Document Description: CSB-SPOT LXI_LED LCD INSTALL	Document Number: 80021534 Version: B

Customer Service Bulletin

Product:	SPOT LXi 4500 Vital Signs	Date:	2016-06-07
Subject:	720480 / DISPLAY,LCD,320X240,LED,MONO,3.3V,5.7" Installation		
HW Version(s) Affected:	SPOT LXi 4500 / All models	SW Version(s) Affected:	N/A
Serial Numbers Affected:	N/A	Lot or Date Code Affected:	N/A
Classification:	As Needed		
Distribution:	<input checked="" type="checkbox"/> Customer Care <input type="checkbox"/> Product Service <input type="checkbox"/> Field Service <input checked="" type="checkbox"/> ASPs <input checked="" type="checkbox"/> Distributors <input checked="" type="checkbox"/> Customers <input type="checkbox"/> Company Confidential		
Training Required:	<input type="checkbox"/> Yes <input checked="" type="checkbox"/> No

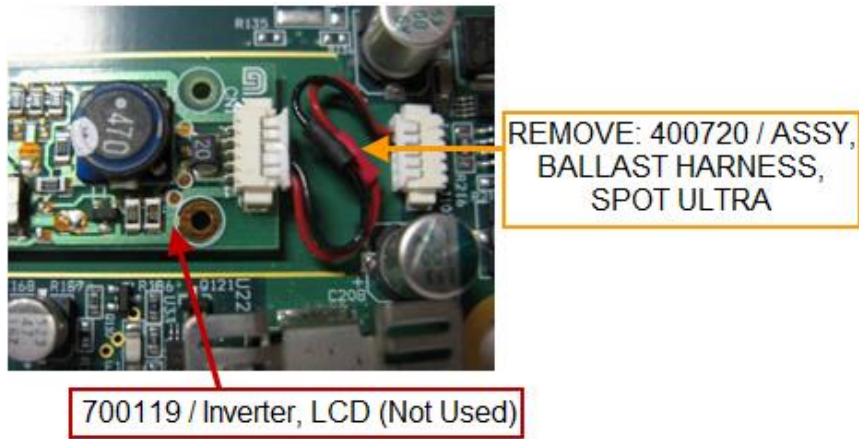
Route the LED Power Cable around the mainboard (as shown):

When replacing a CCFL display (703354) with an LED LCD (720480), remove the Ballast Harness assembly (p/n: 400720) from connector J107 and from the inverter board.

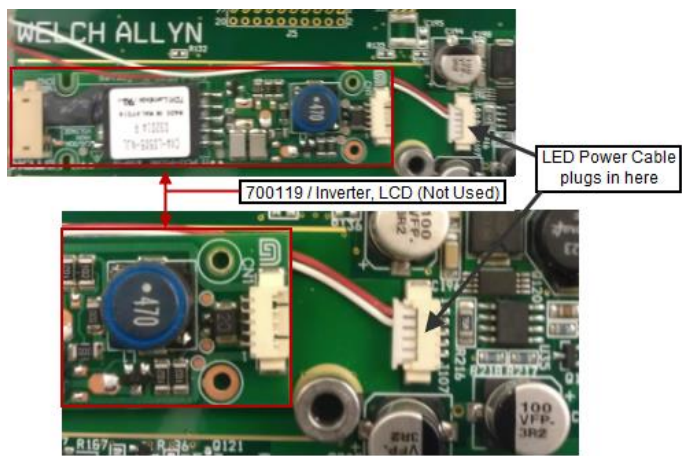
By-pass the inverter board with the LED Power Cable and plug it directly into connector J107 (as shown).

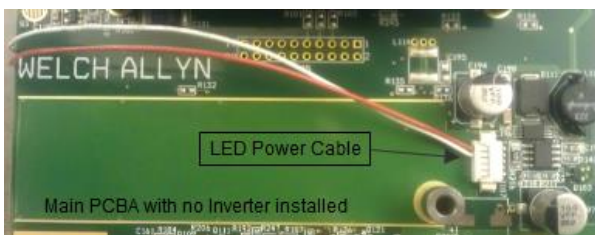
When replacing the LCD in a device that was manufactured after June 2014, there will be no inverter board installed. The LED Power Cable will plug directly into connector J107 (as shown).
